RE: **Lot 23 Block 8 Unit 22 SAD 228**  
**6300 Alderete Ct. NW**  
**Grading and Drainage Plan**  
**Engineers Stamp Date 9/30/2024 (D10D003E23)**

Based upon the information provided in your submittal received 10/1/2024, this plan is approved for Grading Permit.

<p>ENGINEER'S SEAL</p>	<p>LOT 23 BLK 8 U 22 VC 6300 ALDERETE COURT</p>	<p>DRAWN BY DEM</p>
	<p>GRADING AND DRAINAGE PLAN</p>	<p>DATE 9-27-24</p>
<p>9/30/24</p>		<p>SHEET #  C1</p>
<p>DAVID SOULE P.E. #14522</p>	<p>PO BOX 83624 ALBUQUERQUE, NM 87199 (505) 321-9099</p>	<p>JOB #</p>

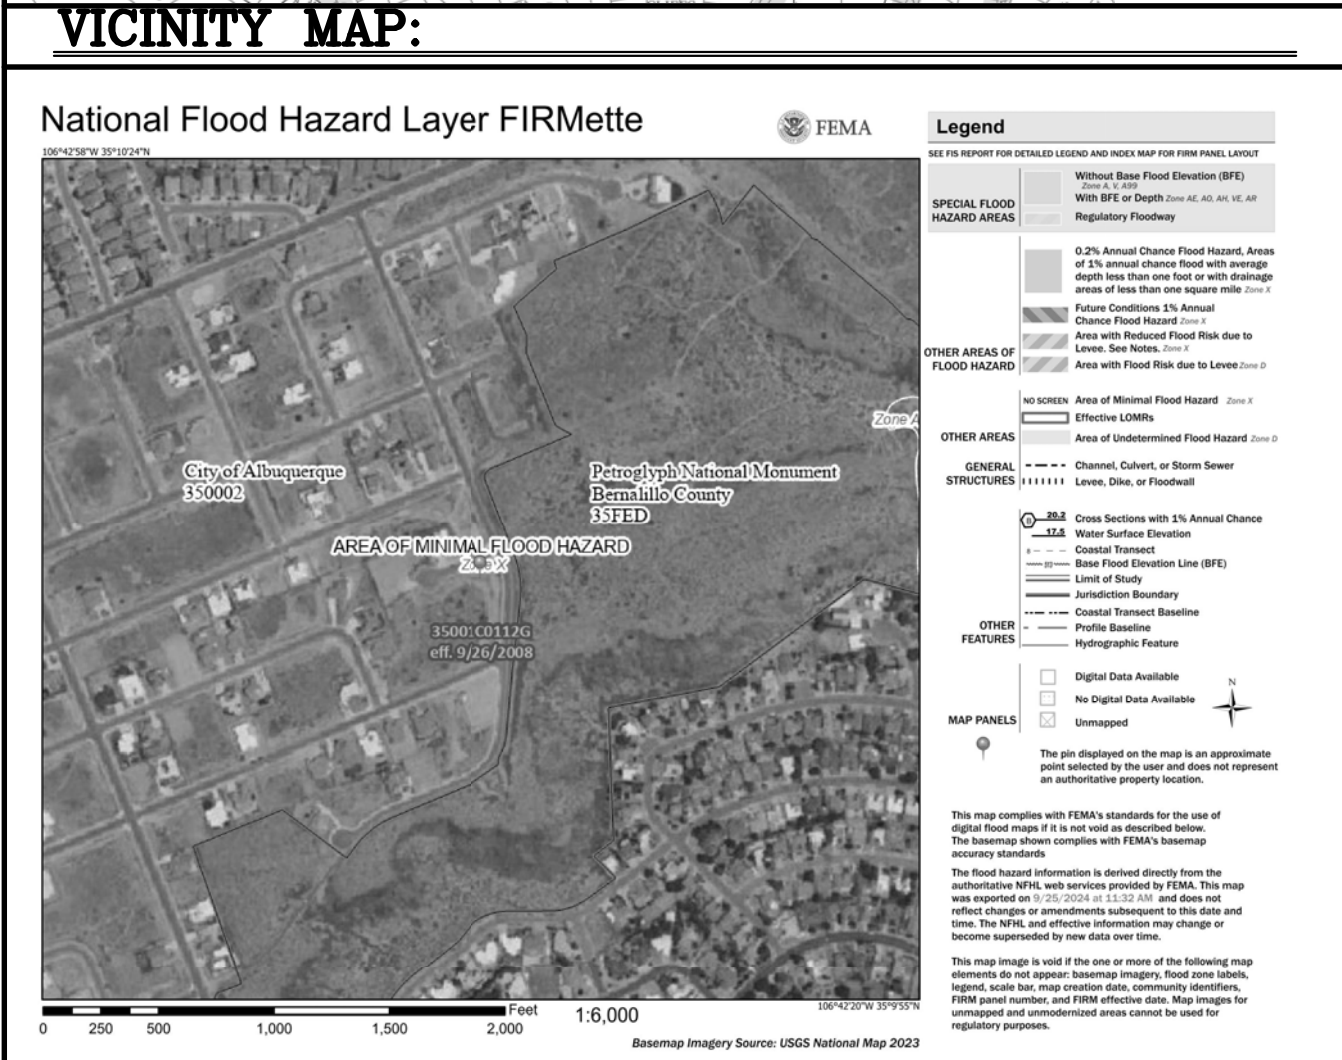
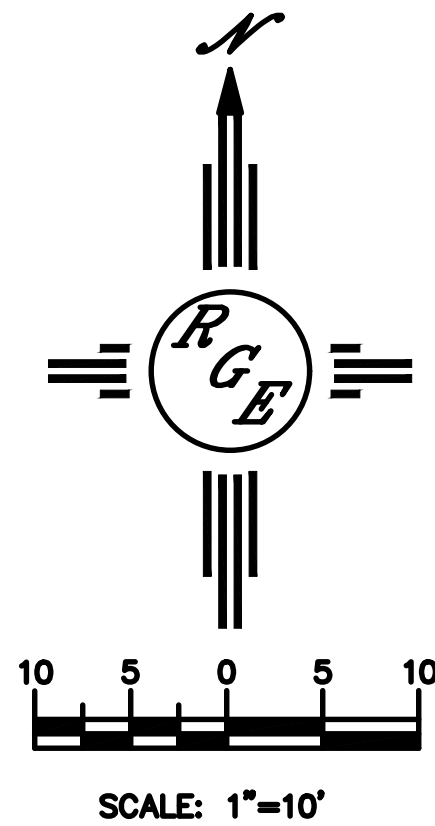
**Prior to Building permit approval a Pad Certification will be required, provided by the Engineer or a registered Land Surveyor.**

**Advise the owner contractor not to use dirt as a ramp to climb the curb, use lumber or crusher fines for this purpose.**

Reiterate to the Owner/Contractor that a separate permit for a garden/retaining wall must be obtained with the approved G&D plan and Pad Certification. Also, if a swimming pool is to be placed the grading and drainage plan will change and will need to be resubmitted.

**Prior to Certificate of Occupancy release, Engineer Certification per the DPM checklist is required.**
